Omaha Public Power District
444 South 16th Street Mall
Omaha NE 68102-2247

October 17, 1996
LIC-96-0151

Subject: Response to Request for Additional Information (RAI) on Toxic Gas Monitors (TAC No. M91397)

**OMAHA PUBLIC POWER DISTRICT
FORT CALHOUN STATION UNIT NO. 1
NRC REQUEST FOR ADDITIONAL INFORMATION (RAI)
TAC NO. M91397**

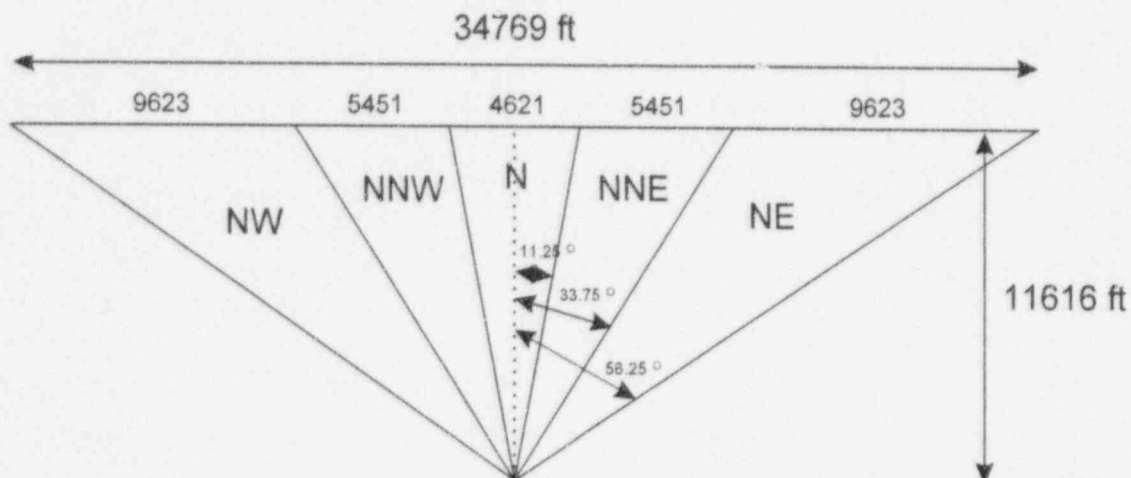
For reference, please provide the title, publishing date, and author of the document which describes the methodology used to calculate the parameter, P_{imp} , which is used in the calculation of the loss of control room habitability frequency.

The parameter, P_{imp} , is not considered a published and referenced entity; rather, it represents the derivation of the factors that influence the probability that an accident could impact the control room. This information was previously provided to the NRC by facsimile on May 8, 1996. The parameter represents the normalized probability that the wind is directed from the hazardous length of track/highway toward the control room. This is determined by partitioning the length of critical track/highway into 22.5° sectors corresponding to the sixteen wind directions with respect to the control room. Consider the example below:

The critical track, located 11,616 feet due north from the control room, has been partitioned into five sectors: NW, NNW, N, NNE, and NE.

Using the Pythagorean theorem, the length of track in each sector has been calculated as shown in the figure. The contribution to the overall probability of plant impact from each sector is the fraction of the total critical length of track in each sector multiplied by the probability of wind blowing from that sector. Assuming the following probabilities of wind blowing from the sectors of concern:

Figure 6.1.2.1

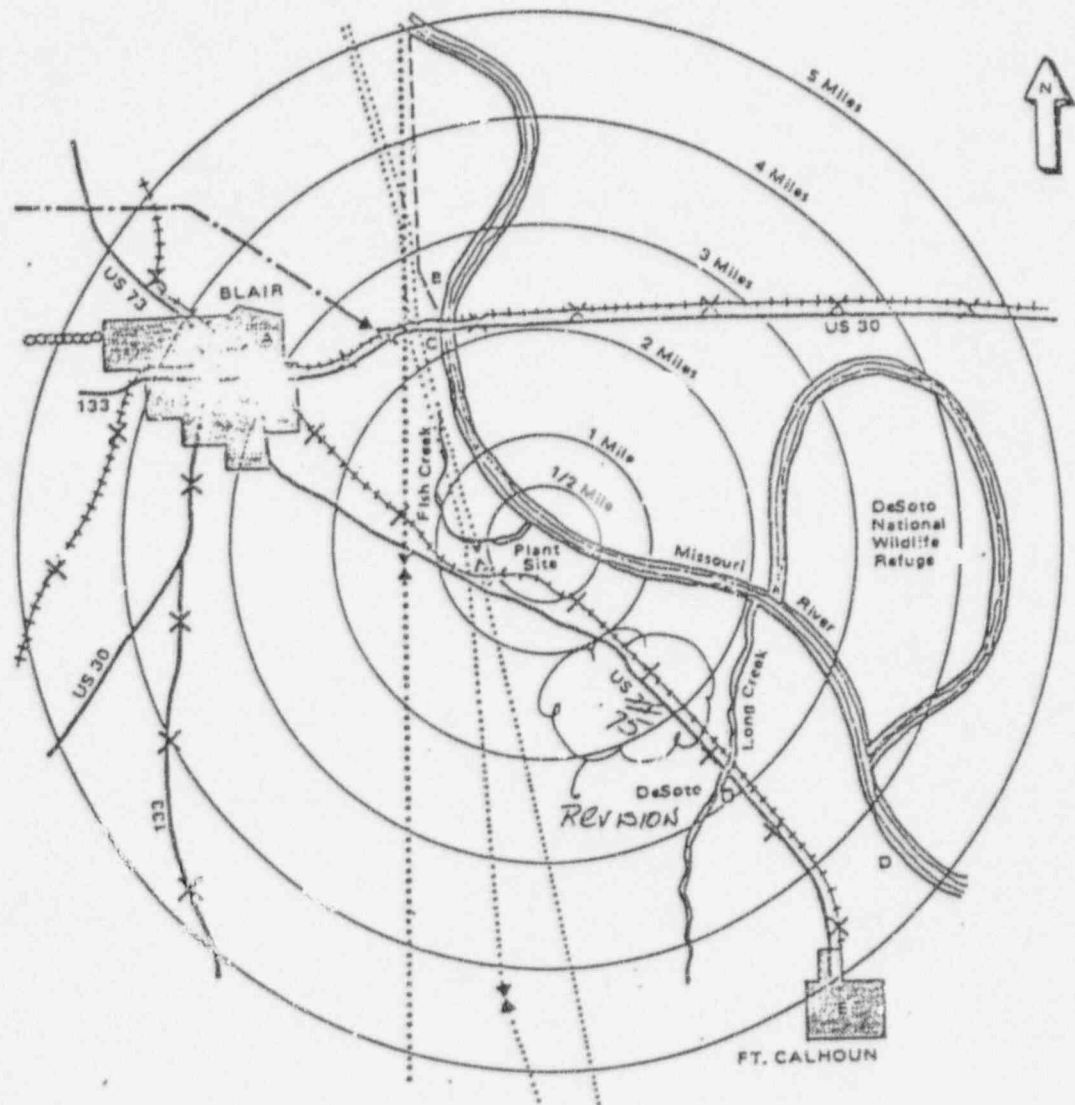
Provide a map which shows the rail and highway transportation routes within a 5 mile radius of Fort Calhoun which are used for transporting ammonia and chlorine. Indicate which routes transport the ammonia and chlorine.

Attachment C provides the requested figure. The figure previously transmitted by facsimile on May 14, 1996, was an excerpt from the 1981 study [3]. Changes since the 1981 study consist of:

- US 73 is now designated US 75,
- Addition of Cargill Corn Processing plant between Blair and FCS, a map of which was transmitted to the NRC [7],
- The rail line shown on the map which goes to the town of Fort Calhoun was abandoned and is now just a rail spur for the Cargill Corn Processing Facility.

The only highway shipment route of concern is the ammonia shipments on US 75. As stated in the introduction, the shipments of ammonia on US 30 and Nebraska 133 do not impact the plant.
